SURGENOR TRUCK CENTRE ADDITION & RENOVATIONS
1571 Liverpool Court, Ottawa, Ontario.

ADDENDUM No. 2 to Drawings and Specifications
Job No. 18-18 - 12 February 2019

PROJECT
SURGENOR TRUCK CENTRE
EXPANSION

DRAWING NO.
ADD#2/A-01

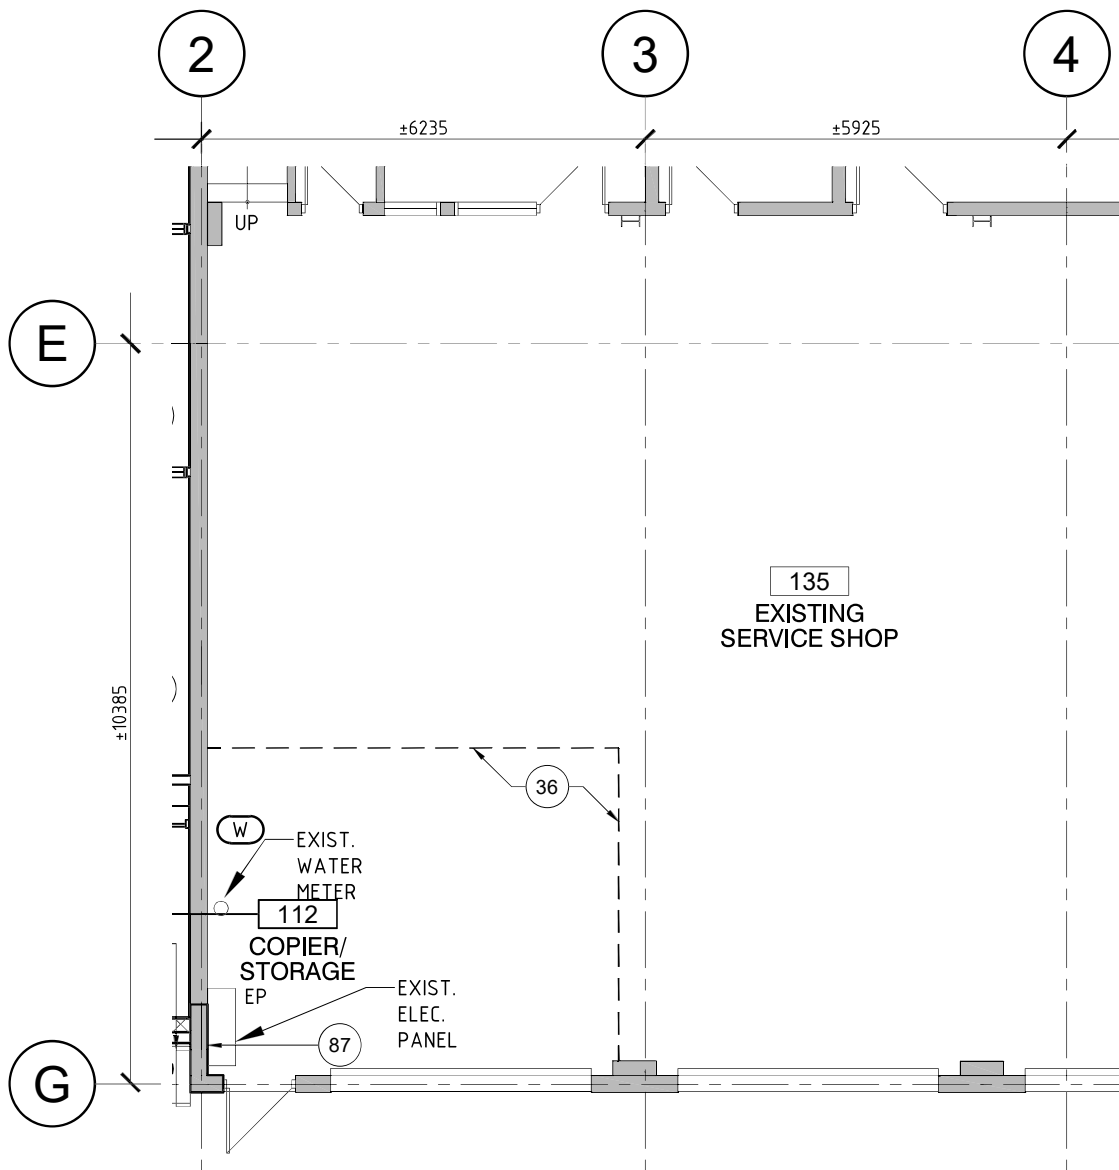
1. Clarification to the aluminum framing, windows, and doors:
 - a. Exterior windows are aluminum window framing with top hats except at entrance doors where full height glazing is thermally broken entrance framing. Interior vestibules are entrance framing.
 - b. Interior windows, half height are PC350 or CRL487, framing. Wall below are typical drywall partitions.
2. Area of floor to be blast tracked, Note 80, is for the entire area of the new Room 133. See attached drawing ADD#2/A-01.
3. Delete fire shutter, Door 133A and Note 72. Make good opening with drywall and paint. See attached drawing ADD#2/A-01.
4. Reduce size of hoarding wall in Room 135 as shown on attached drawing ADD#2/A-02.

- (36) CONSTRUCT TEMPORARY FULL HT. WALL:
 13mm GYPSUM SHEATHING
 92mm STEEL STUDS
 BATT INSULATION
 13mm GYPSUM BOARD
 (CAULK & TAPE ALL PERIMETERS FOR DRAFT SEAL)

DRAWING NO.
ADD#2/A-03

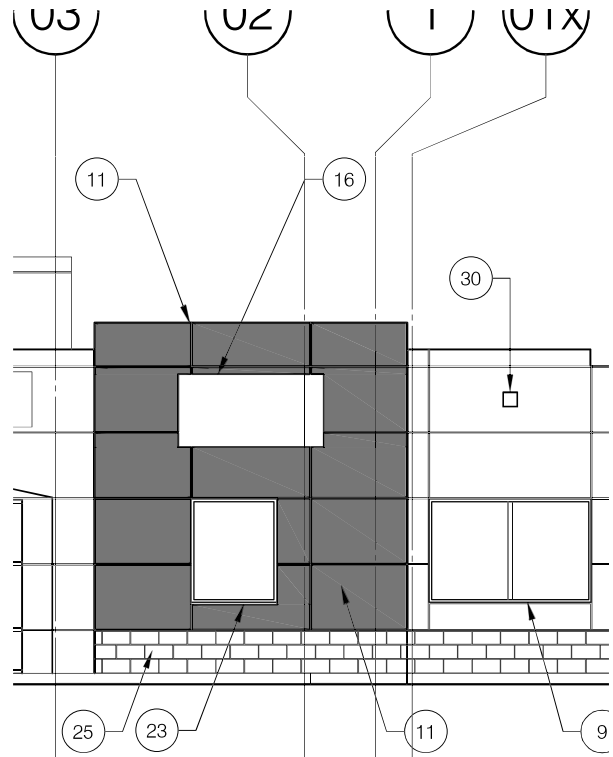
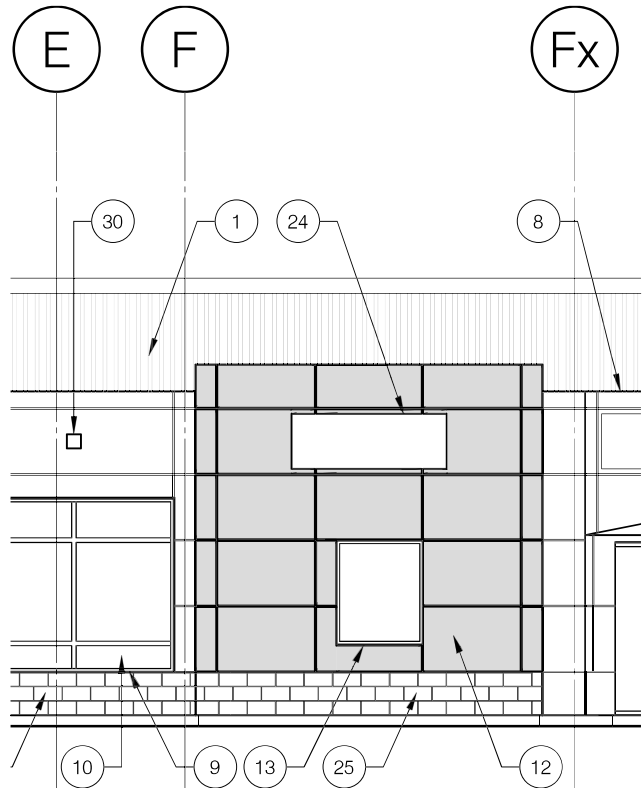
- a. Canopy face, parapets, and column surrounds to be "Web Grey".
 - b. Aluminum panels to be "Black" at the location shaded on the attached Drawing ADD#2/A-03. Include the returns to the main face of the building elevation.

- c. Aluminum panels to be "White" at the location shaded on the attached Drawing ADD#2/A-03. Include the returns to the main face of the building elevation.
